VALUE ENGINEERING SUMMARY OF US 119/ZEBULON TO BENT MT. WPI NO. 12-308.1 & 308.2 PIKE COUNTY, KENTUCKY

Prepared by: Ventry Engineering

Kentucky Transportation Cabinet, Department of Highways

V.E. ALTERNATIVE NO. 1 - Use Retaining Walls & Steepened Slopes

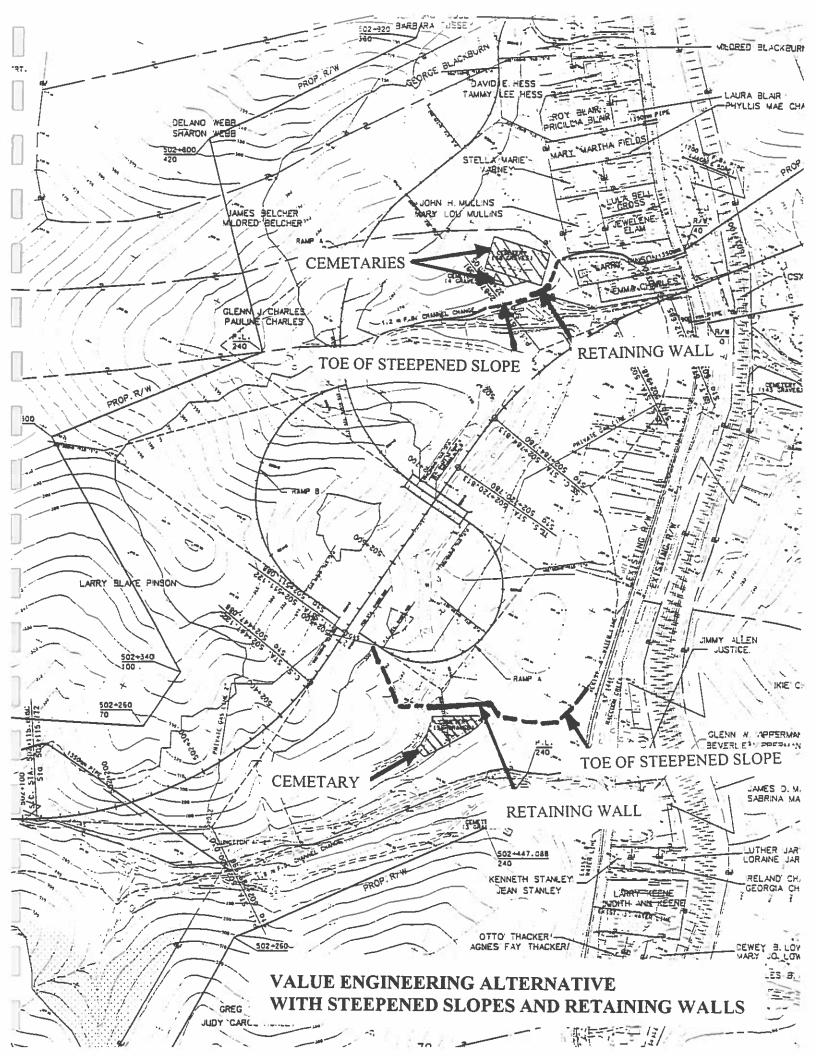
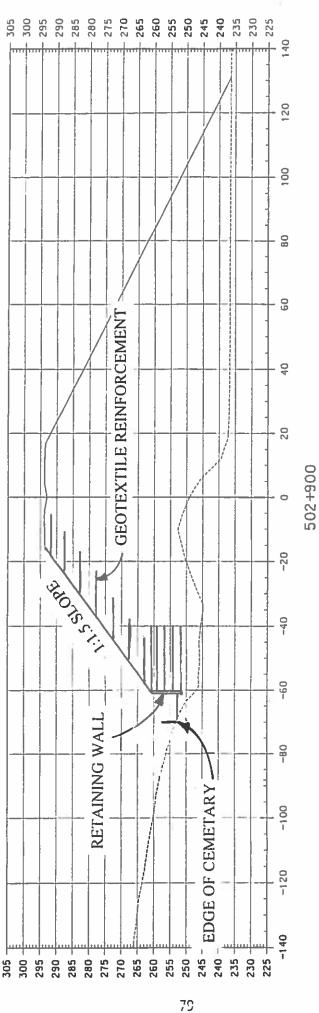
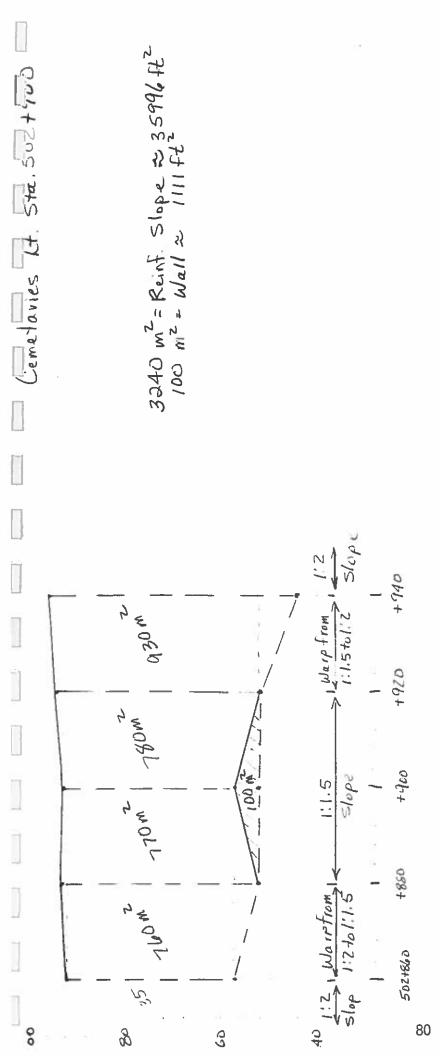
This alternative uses MSE walls and 1:1.5 slopes reinforced with geotextile to reduce the footprint of the fill and avoid grave relocation.

V.E. ALTERNATIVE NO. 2 - Steepened Slopes

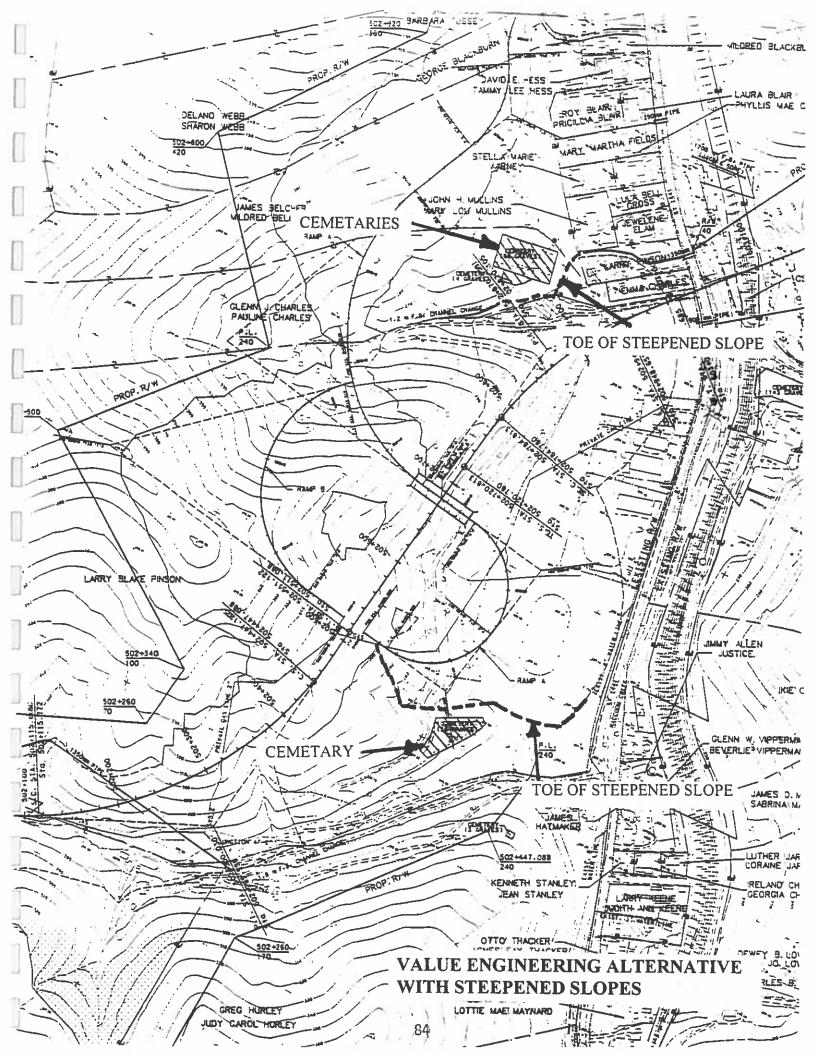
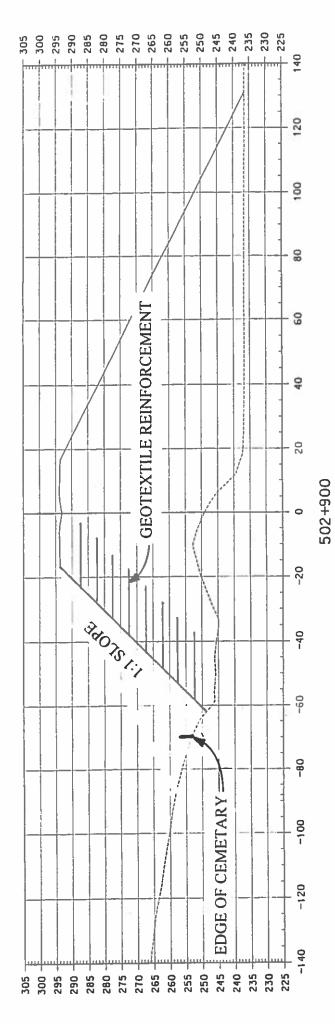
This alternative uses 1:1 slopes reinforced with geotextile to reduce the footprint of the fill and avoid grave relocation.

WINN BRANCH

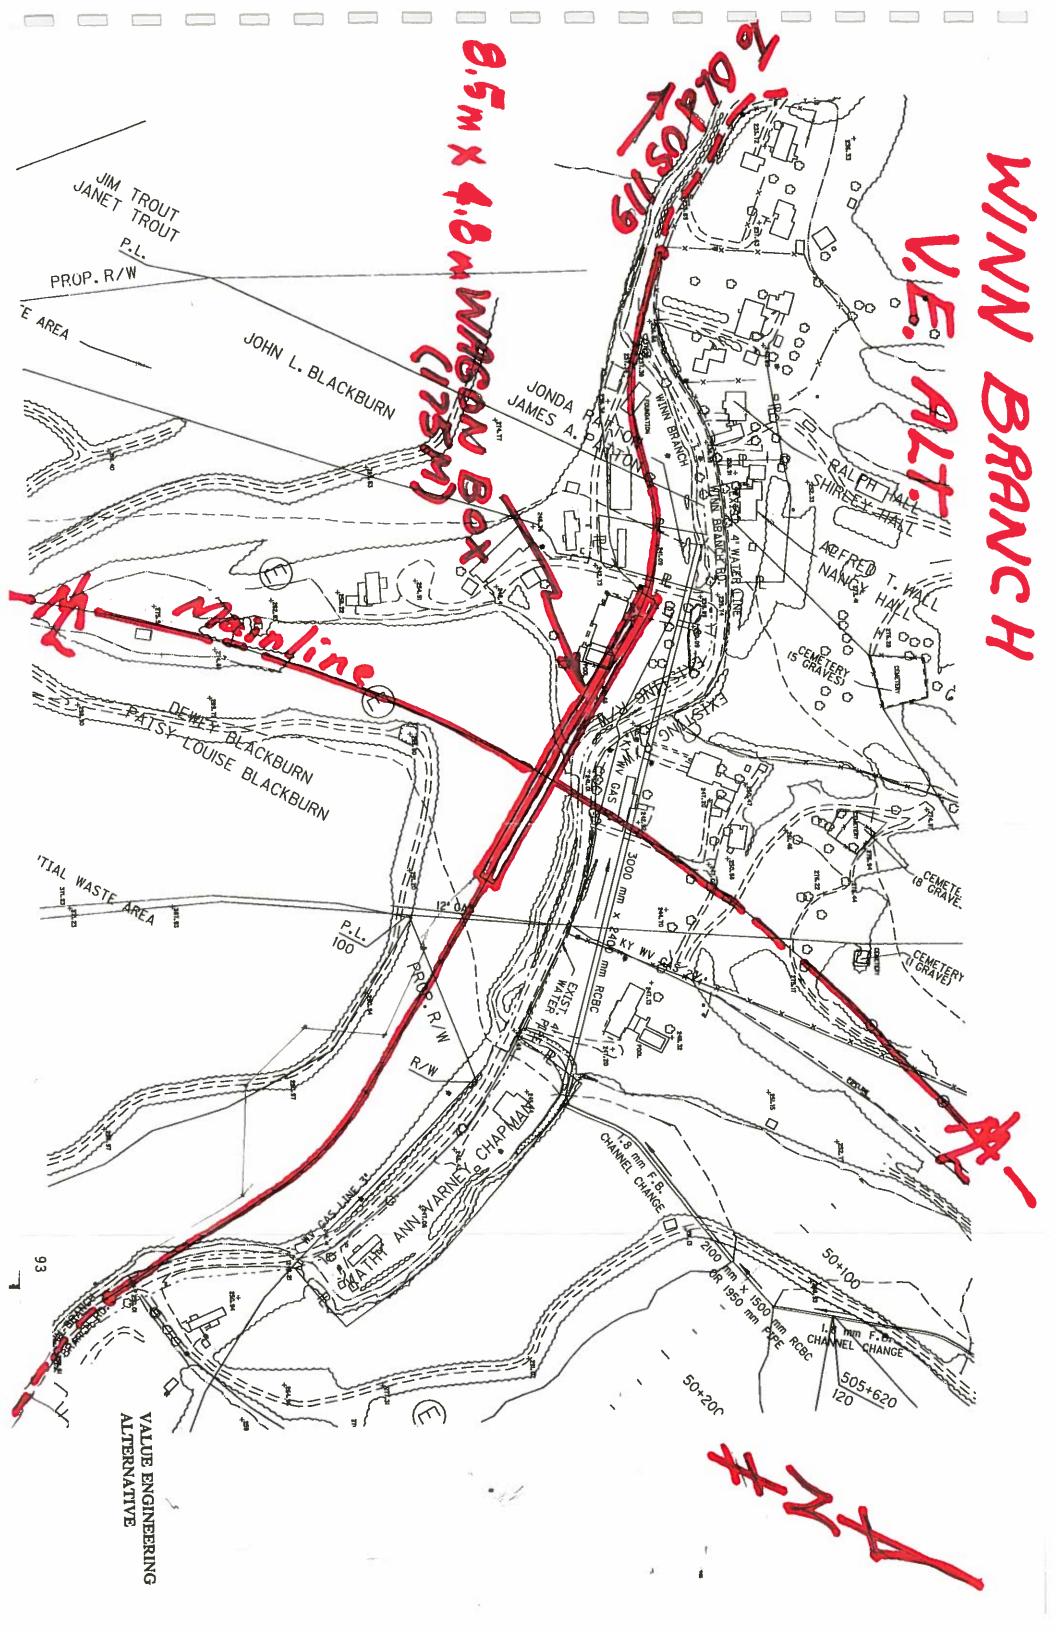
The V.E. alternative provides no access to the mainline but does maintain existing access to old U.S. 119 for all residences on Winn Branch Road. The V.E. alternative eliminates the proposed access road and the at grade intersection on the mainline and utilizes a $8.5m \times 4.8m$ Wagon Box through the embankment at station 505 + 300. The primary advantages her would be:

- 1. Maintaining neighborhood integrity.
- 2. Equal access for all Winn Branch Rd. residences.
- 3. Elimination of at grade intersection and resultant median crossing.

The primary disadvantages would be:

1. Increased cost.
